Re: Indian Point Unit No. 2
Docket No. 50-247

In response to your letter of June 29, 1983, our letter of July 29, 1983 indicated that we would submit supplemental information in order to resolve concerns raised by the NRC staff in their draft SER. In subsequent telephone conversations, the staff requested additional information relative to the Appendix R exemption requests addressed in our January 10, 1983 and July 13, 1983 submittals. Enclosure 1 to this letter describes supplemental modifications for Indian Point 2 in order to more fully justify exemption requests submitted under 10 CFR 50.48(c) in our January 10, 1983 submittal. Enclosure 2 provides the fire hazards evaluation for the IP-1 Superheater Building and the construction of the non-rated steel wall separating the Central Control Room from the Alternate Safe Shutdown System cables located in the adjacent corridor. Enclosure 3 addresses various items related to emergency lighting, including supplemental information on exemption requests submitted under 10 CFR 50.12 in our July 13, 1983 submittal, clarification of emergency lighting for the containment area, and a description of our planned emergency lighting program. En

FIGURE I
CONTROL ROOM/SUPERHEATER BUILDING INTERFACE

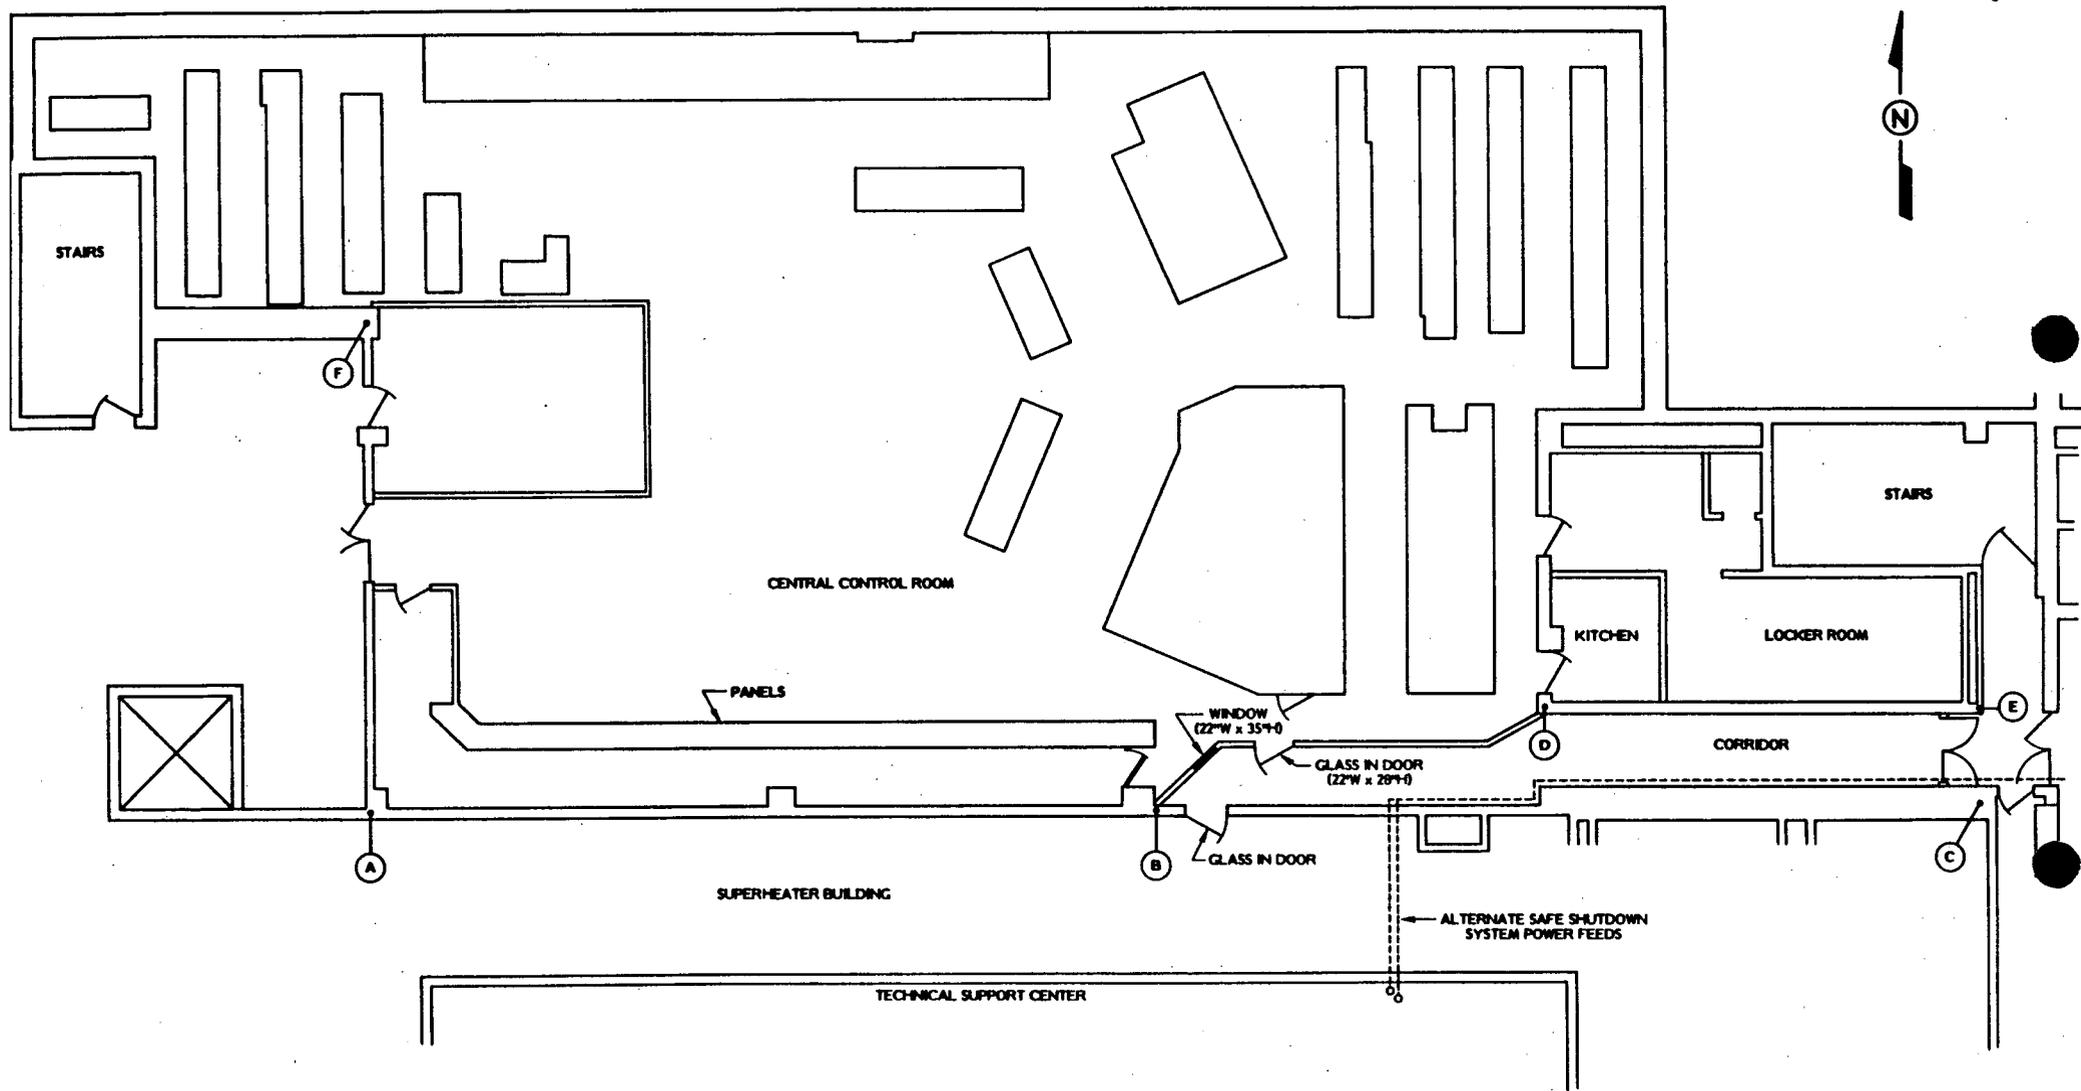
- Elevation 53' - This level of the Superheater Building is separated from the CCR by a wall of multi-course brick construction. A separate wall comes off of the brick wall forming a corridor between the brick wall and the CCR as shown by Figure 1. Wall construction between points A and C and between points D and E in Figure 1 are multi-course brick construction. Cable tray and conduit penetrations between points A and B are sealed so as to avoid combustible pathways between the Superheater Building and the CCR.

Wall construction between points B and D from Figure 1 is steel panel construction. The wall is substantial steel clad over a hollow wall. Overall wall thickness is approximately 5 inches. With the substantial steel construction and the air space in the wall, substantial restriction to the propagation of fire is provided. Penetrating the steel clad wall is a non-rated door containing bullet-proof glass, approximately 22" wide by 28" high. Additionally an

observation window, of bullet-proof construction, 22" wide by 35" high is located in the wall as shown in Figure 1.

With the substantial wall between points A and C that is separating the CCR and the corridor from potential hazards in the IP-1 Superheater Building, and with the limited combustibles contained in the Superheater Building, the potential fire exposure to the steel wall would be extremely small. With this limited hazard, it is judged that the brick walls and the steel clad wall with the security door and window provide adequate barriers to protect the CCR from potential hazards in the Superheater Building. Additionally, the steel wall will provide a substantial barrier to protect ASSS cables routed in conduit in the corridor from potential fire hazards in the CCR.

Based on the above information, we find that the Superheater Building contains a low fire load and does not present a fire hazard to the CCR. Additionally the south wall separating the CCR from the adjacent corridor is of adequate construction to protect the alternate safe shutdown cabling in the corridor from a potential CCR fire, and vice versa. Accordingly, with the repairs to be made to the CCR floor penetrations as noted in Enclosure I, Exemption Request 4.9 should be acceptable.
